UNDER-PINNING SATGHARA REST-HOUSE.

By. K. R. SHARMA, ASSISTANT ENGINEER, P. W. D. IRRIGATION.

DISCUSSION.

SKETCH SHOWING THE UNDER PINNING OF INTERIOR WALLS

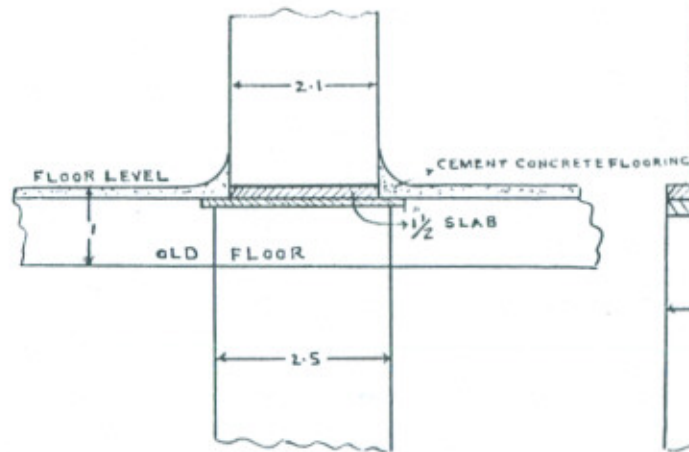
Mr. Sardari Lal Malhotra said that he wished to point out one or two defects in the design as shown in the sketches. He instanced sketch No. 1 of diagram No. 2, where the damp proof course had been shown at the level of the floor which overlapped it, and remarked that if that was the way things had been done, kallar would appear again. The damp proof course ought to have been laid at least $\frac{1}{4}$ " above the floor level and clear of it.

The Author replying to the discussion said with reference to the remarks of Mr. Sardari Lal Malhotra that the floor in all rooms and verandahs consisted of 2'0 feet depth of sand covered with .25 feet foundation concrete and followed by 1½ inch thick conglomerate cement flooring. He did not agree with the suggestion of Mr. Sardari Lal Malhotra that the joint of the floor with the walls should be vertical and at a lower level than the damp proof course as sketched below.

The salts had actually risen up to the very bottom of the damp proof course and there was nothing below this level to check their rise. It would result in concentration of the salts at A by evaporation. The damage to the floor would start at the surface of the floor even if the proposed floor were effective. A vertical joint, as at A, between two different materials, the masonry of the wall and the concrete of the floor, was bound to crack, affording free passage of the salts to the surface of the floor. The joint proposed by the Author shown in the sketches in diagram No. II ensured complete overlap of the 1½" thick cement floor over the bottom layer of the damp proof course slabs and a good joint was ensured in rich cement. There was no chance of direct evaporation of the salts in the wall below the damp proof course. There had been no signs of the failure of the joints of the floor with the walls anywhere in Satghara Rest House during the past two years.

UNDER PINNING OUTER MAIN ROOM WALLS

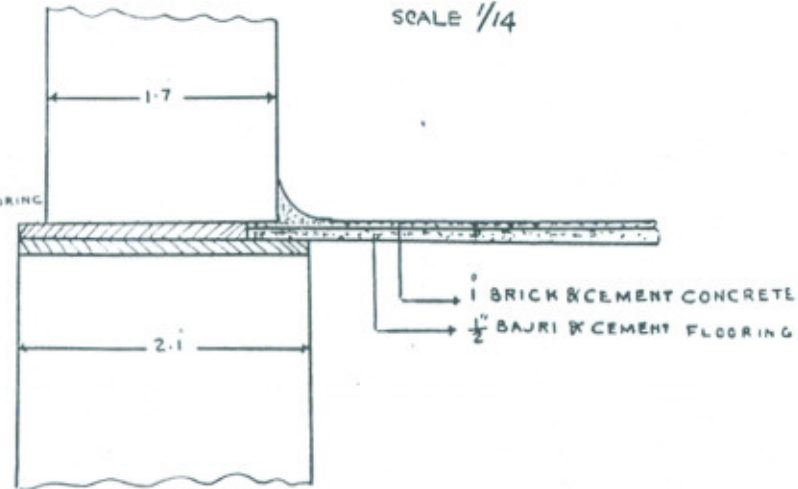
Further, in sketch No. 2, of diagram No. 2, the lime concrete of the floor had been shown projecting into the wall and abutting against the top slab of the damp proof course. This arrangement was defective and did not afford any protection against Kallar.
